**PURPOSE:** Gardom Pond Decommissioning Design Brief **AMENDMENT**

**DATE:** March 4, 2019 **FILE:** 16-1856

**SUBJECT:** **Gardom Pond Dam Decommissioning/Naturalization Design Brief – Breach at Original Stream Channel**

**PROJECT:** GARDOM POND, NORTH PENDER ISLAND DAM NATURALIZATION DAM AREA DETAILS  
**CONTRACT # 18-1856C**

**27-M156-C3** ISSUE 1

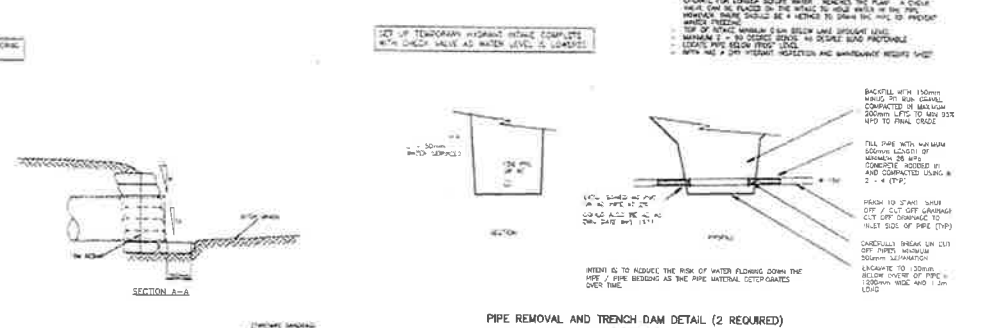
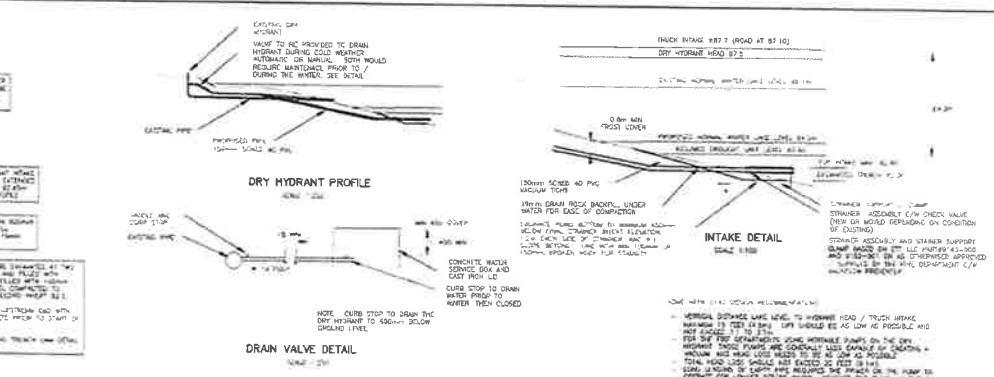
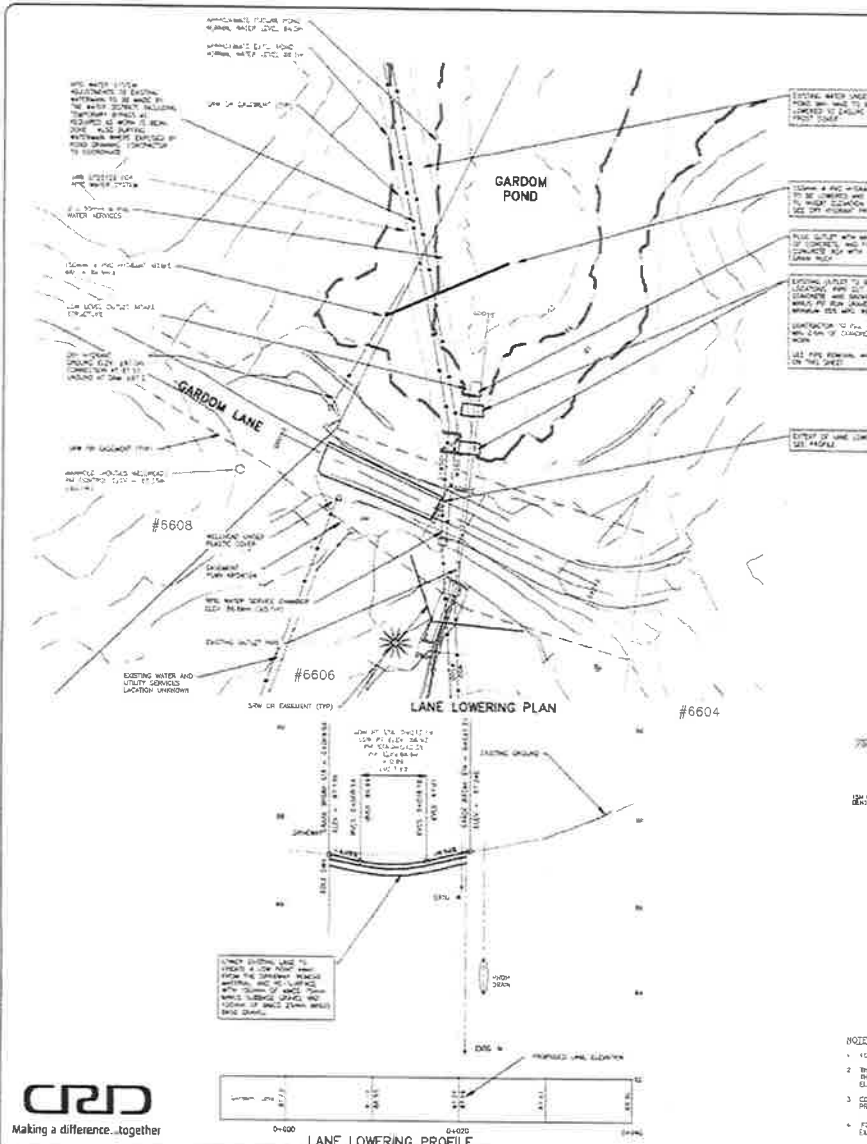
The proposed outlet channel would be cut into the existing dam embankment with a 900 mm culvert (inlet invert 84 m, outlet invert 83.9 m) with the downstream channel extending approximately 160 meters to the Harbour Hill Drive RROW (El. 42 m). At the tie-in point a 0.9 m sump, lined with riprap, will be instated. The stream outlet channel would be riprapped with 150 mm nominal riprap over a geotextile filter cloth and measure 3 m wide by 0.45 m deep.

However, due to anticipated future flow intensities greater than the 200-year period due to climate change, modifications will be undertaken further downstream. Accordingly, as part of the decommissioning work, a 600 mm culvert will be installed within the RROW at the junction of Harbour Hill Drive and Razor Point Road. In addition, drainage improvements will be undertaken at 6618 Razor Point Road which will include replacing two 400 mm culverts with 600 mm culverts and fortifying the existing outlet channel.

The existing dam embankment will be lowered by 0.35 m and remain in place and continue to serve as an access road to 6604 and 6602 Harbour Hill Drive. The existing low level outlet pipe extending through the dam embankment will be sealed with concrete. The existing 6" dry hydrant located on Gardom Lane directly to the west of the dam embankment will remain operational. An updated environmental impact assessment of the lowering of the water level in Gardom Pond is underway.
